**DOCUMENT 00 91 03  
ADDENDUM NO. 3**

PROJECT: 2024 Smith and Spillane MS Renovations  
BID DATE: **Thursday, February 20, 2025 (no Change)**  
FROM: Carolina Weitzman, A.I.A.  
Natex Corporation Architects  
447 Heights Blvd, Houston, TX 77007  
TO: **Prospective Bidders**

Project Number: 23073  
 Date: 26 JANUARY 2025  
 Drawn By: WHL / KLO  
**ELECTRICAL POWER FIRST FLOOR PLAN - AREA 'C'**  
**E3.03**

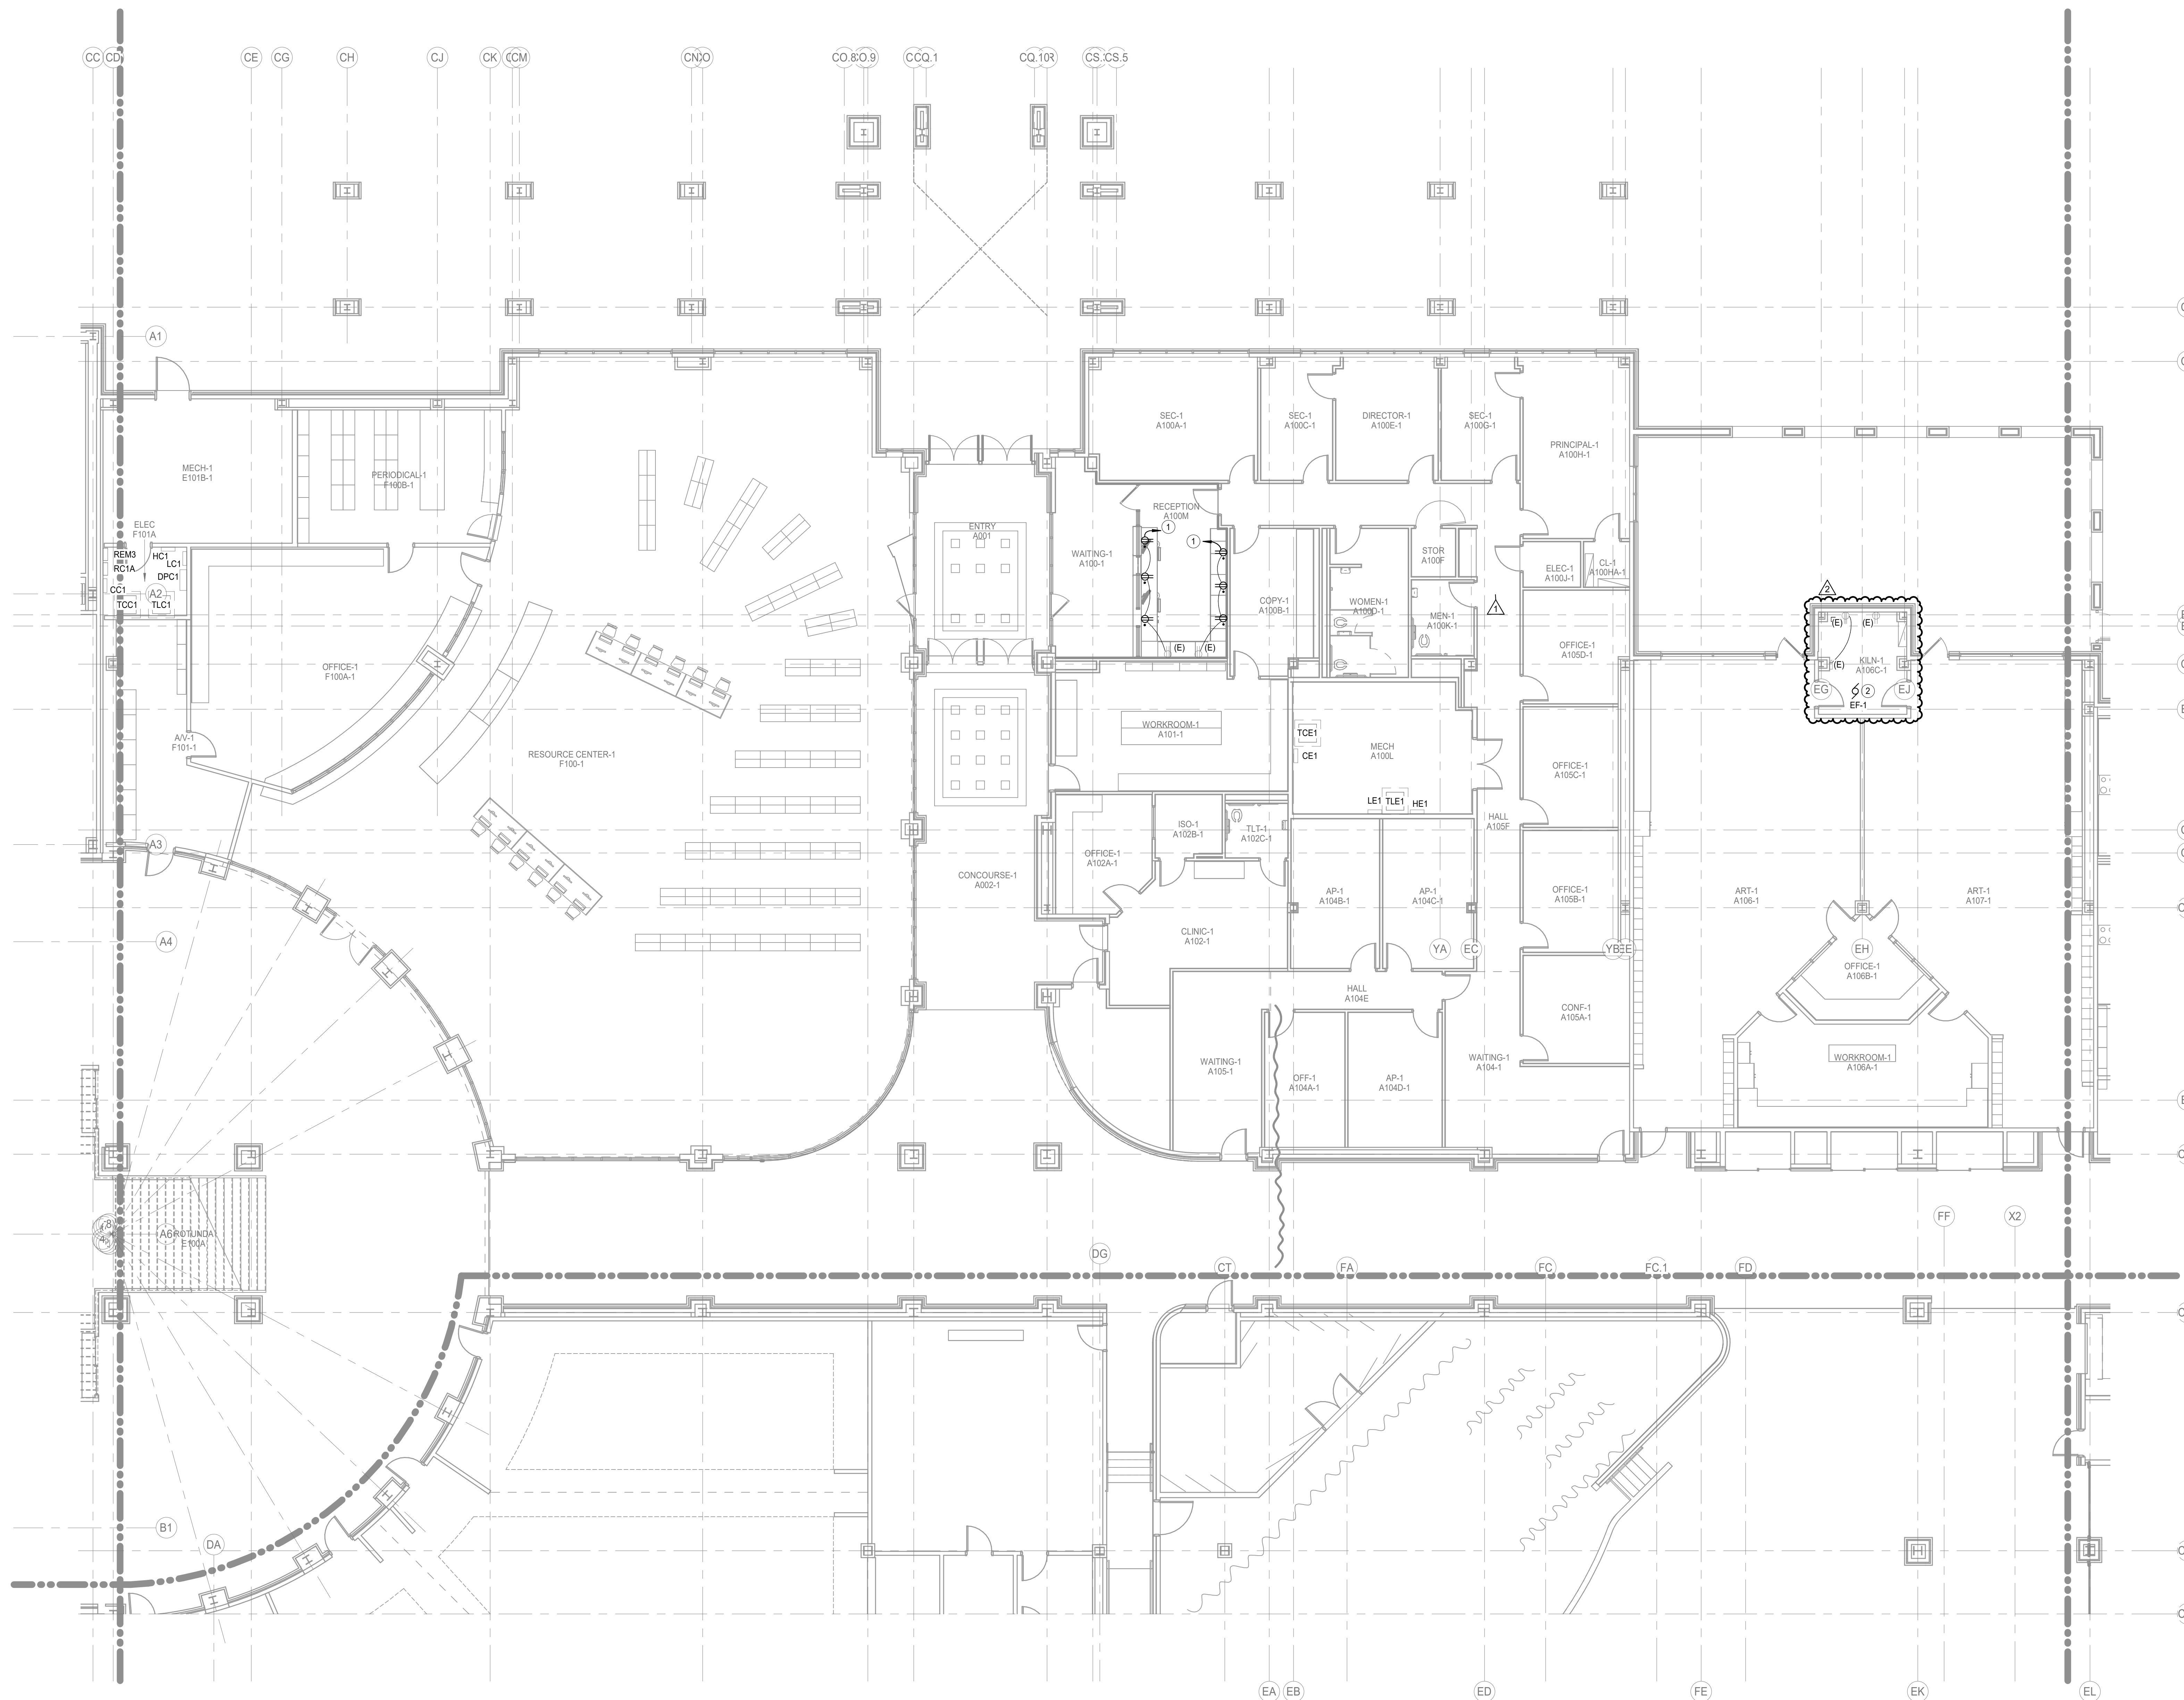
- a. Lighting layout revisions as noted.
22. E3.03 - ELECTRICAL POWER FIRST FLOOR PLAN -AREA 'C'
  - a. Power provided for new Kiln EF-1.

Project Number: 23073  
 Date: 26 JANUARY 2025  
 Drawn By: WHL / KLO  
**TECHNOLOGY DEMOLITION FIRST FLOOR PLAN - AREA 'D'**  
**T0.04**

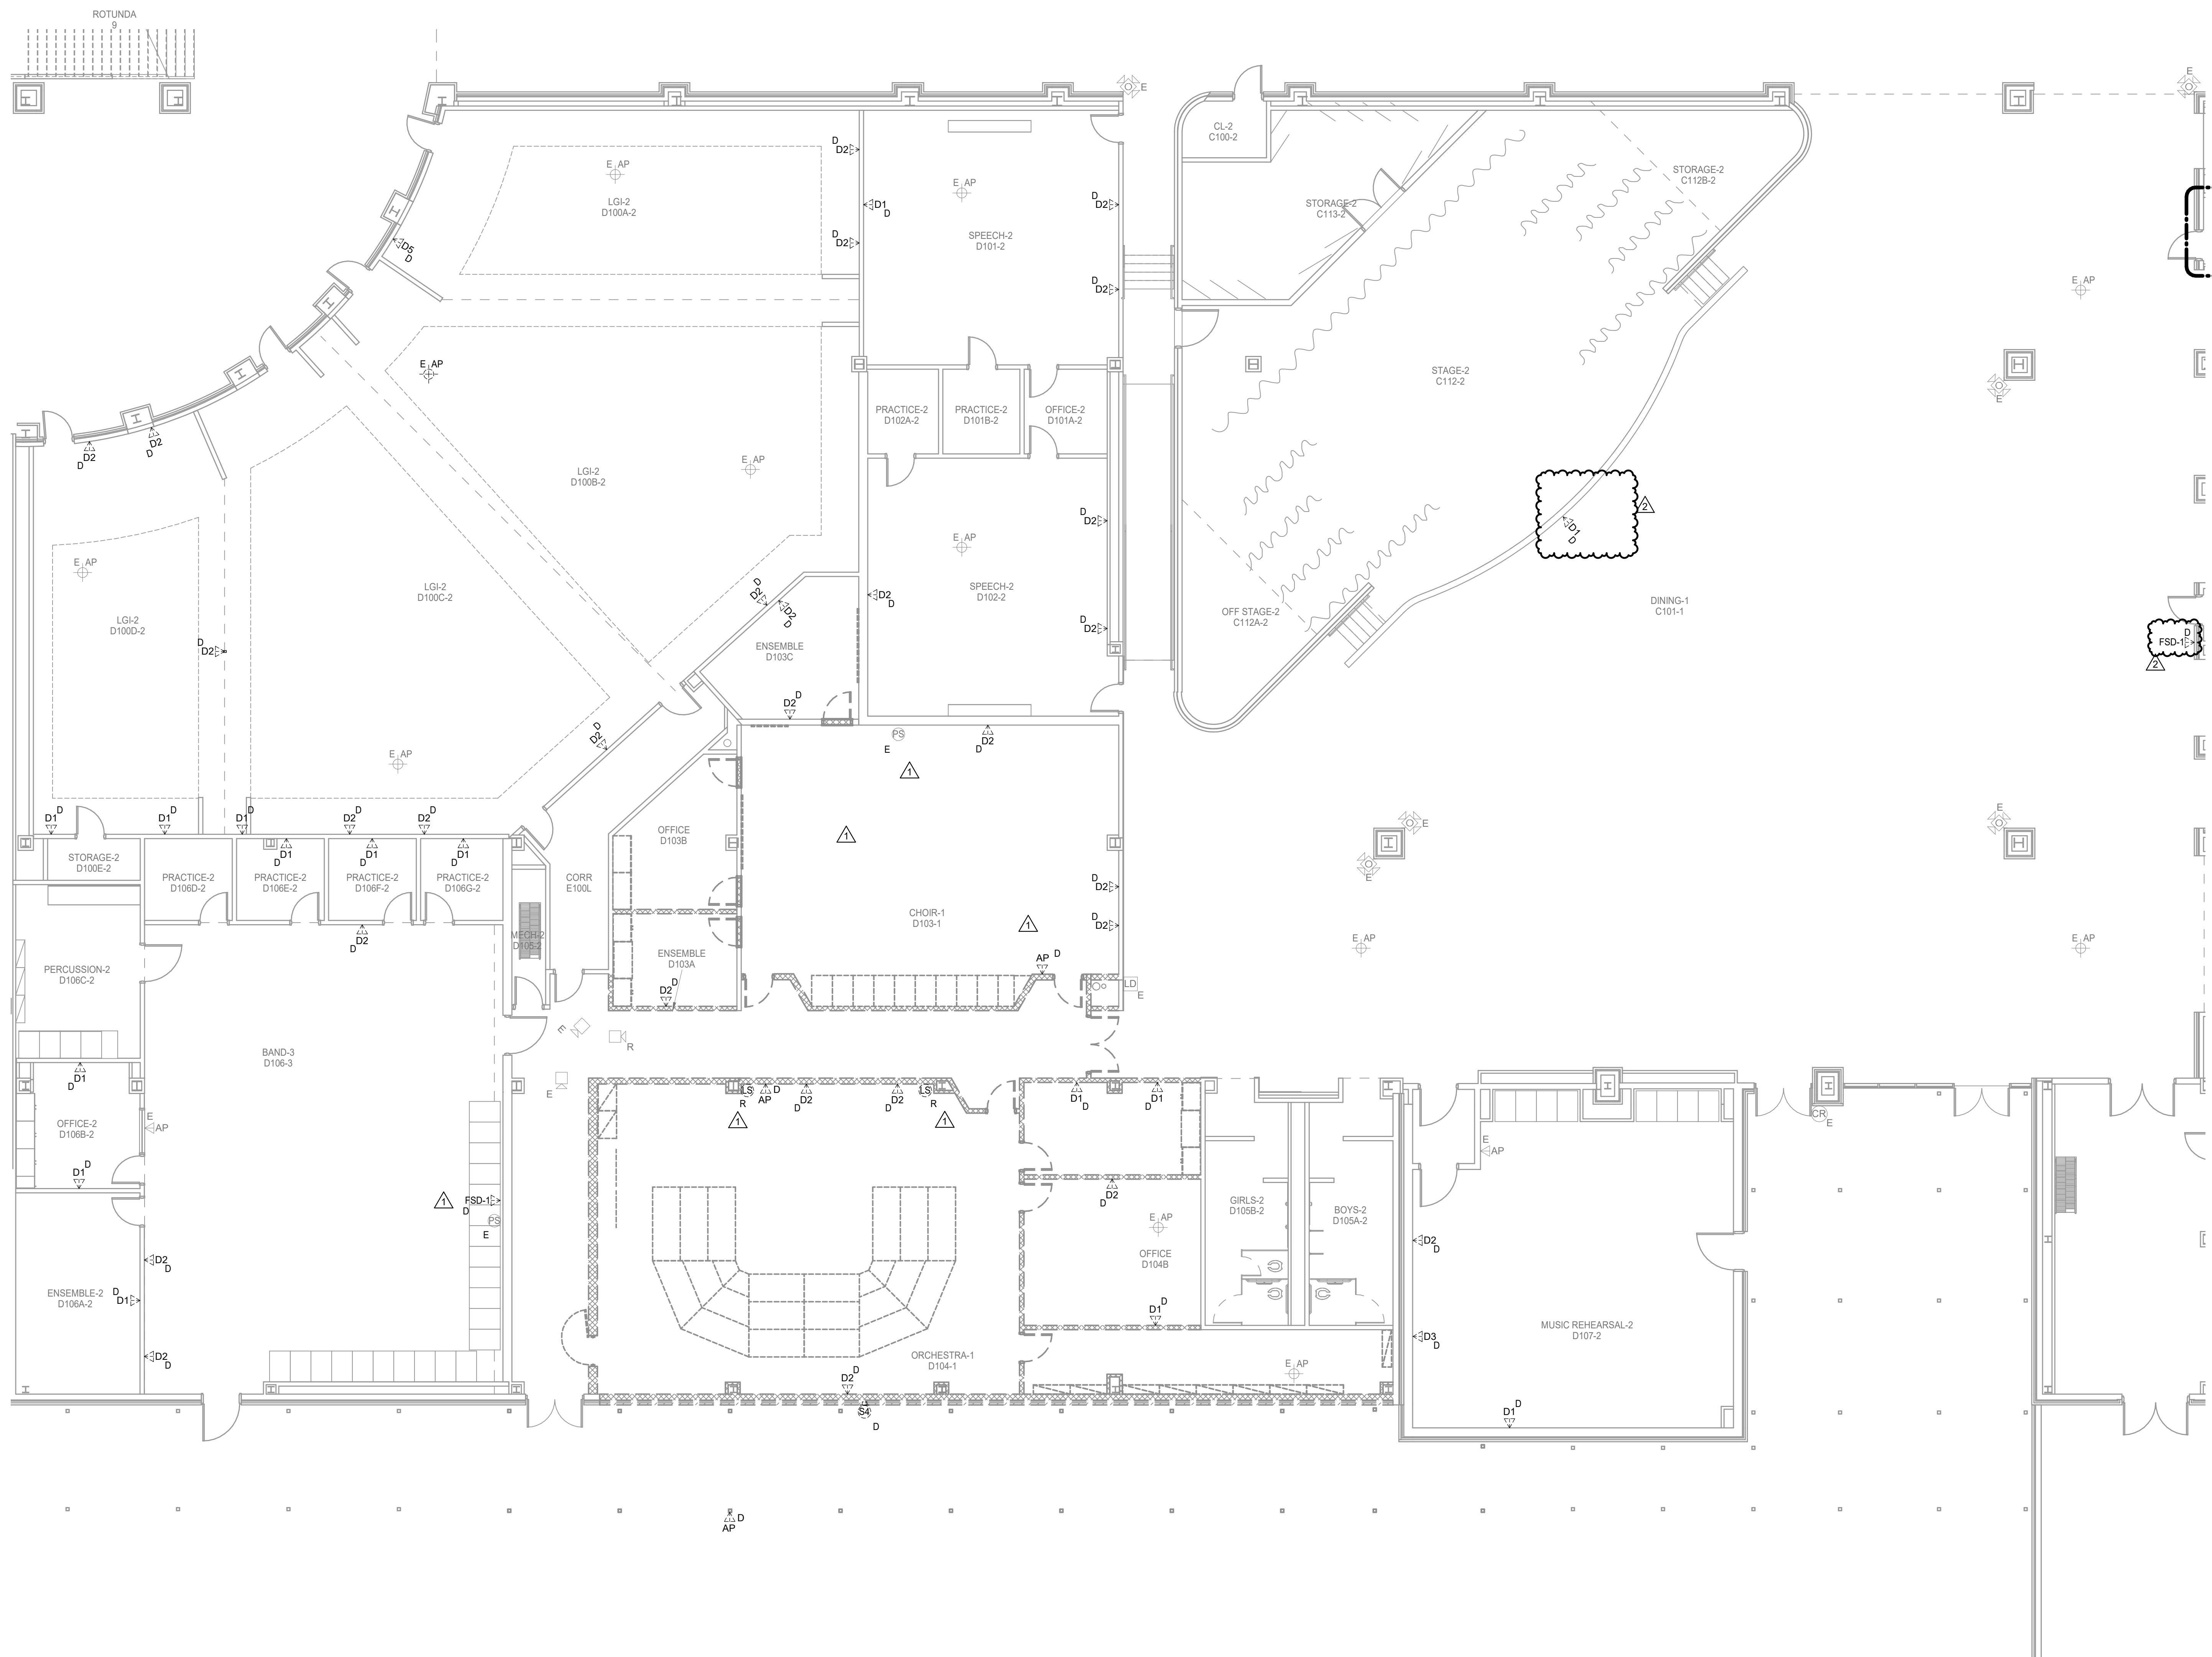
- a. Changes made to panel LJ1.
25. T0.00 – TECHNOLOGY NOTES AND LEGENDS
  - a. Refer to revised plan for fire alarm remote power supply symbol.
26. T0.04 – TECHNOLOGY DEMOLITION FIRST FLOOR PLAN – AREA 'D'

- a. Refer to revised plan for additional drops to be removed in cafeteria.
27. T0.05 – TECHNOLOGY DEMOLITION FIRST FLOOR PLAN – AREA 'E'
  - a. Refer to revised plan for additional drops to be removed.

T1.00

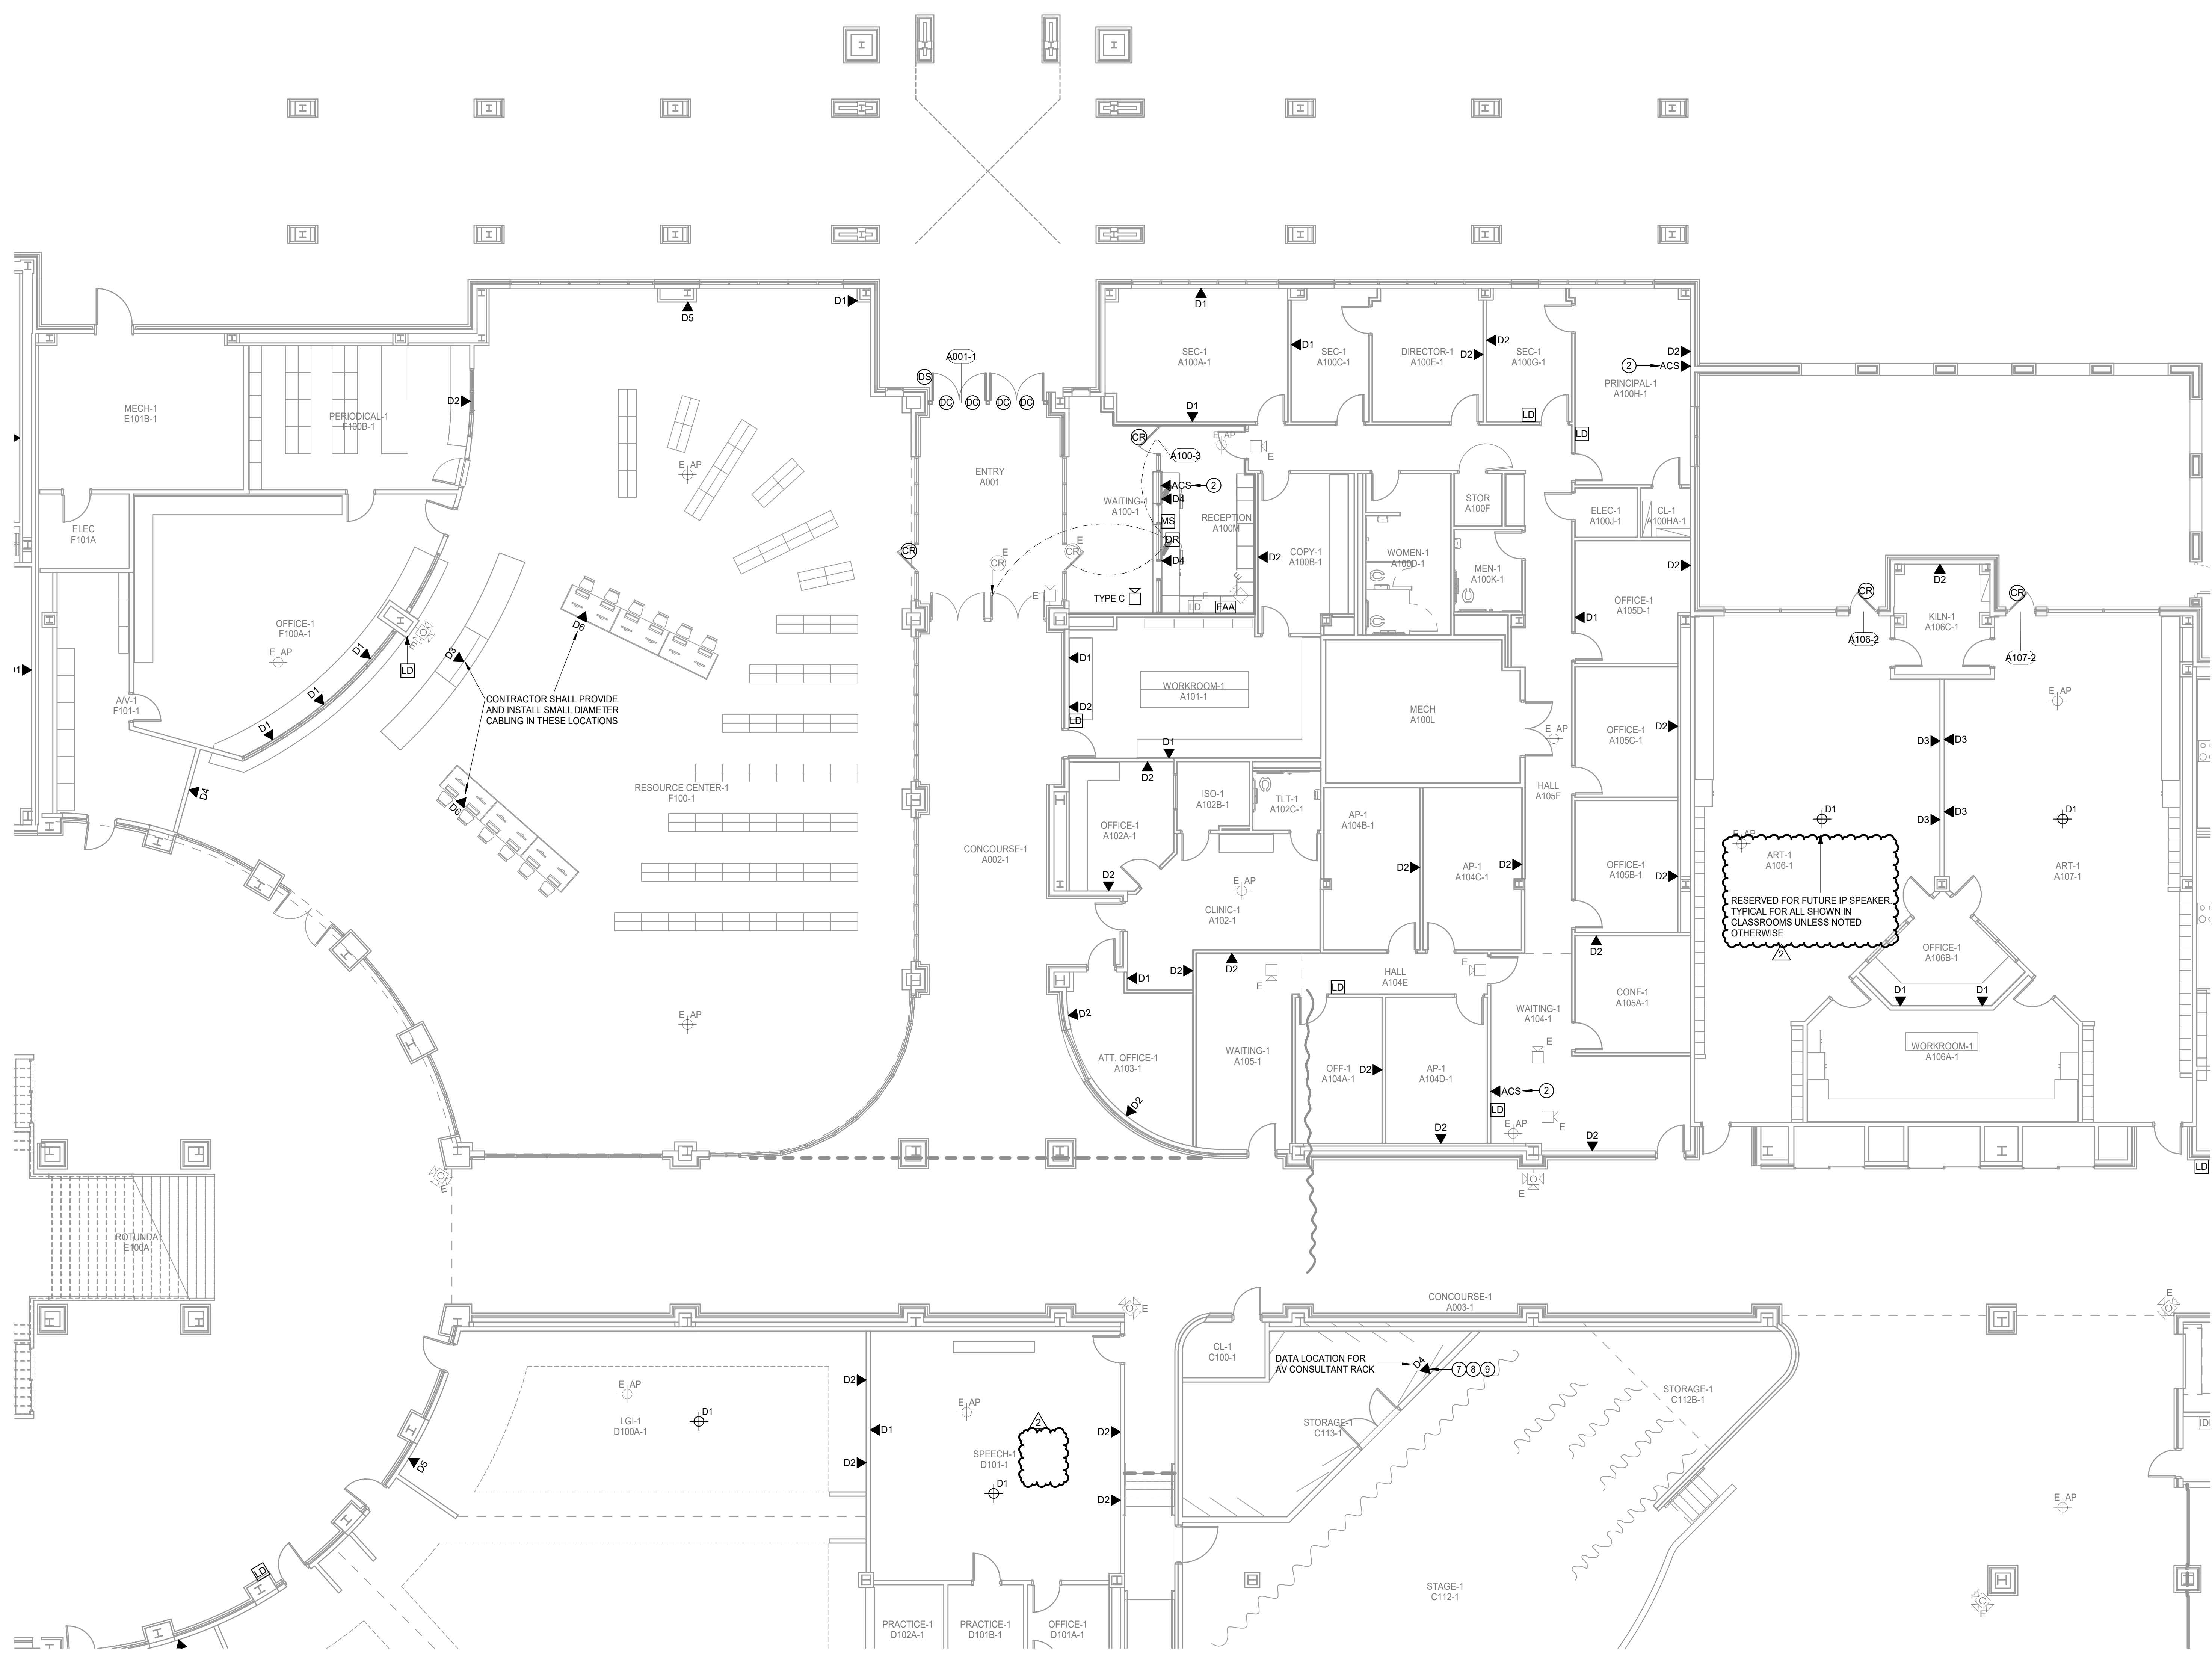
28. T0.11 – TECHNOLOGY DEMOLITION SECOND FLOOR PLAN – AREA 'B'
  - a. Refer to revised plan for additional drops to be removed.
29. T1.00 – TECHNOLOGY COMPOSITE FLOOR PLANS

- a. Refer to revised plan for fire alarm remote power supply locations.
30. T2.03 – TECHNOLOGY FIRST FLOOR PLAN – AREA 'C'
  - a. Refer to revised plan for additional drop location and ceiling drop clarification.
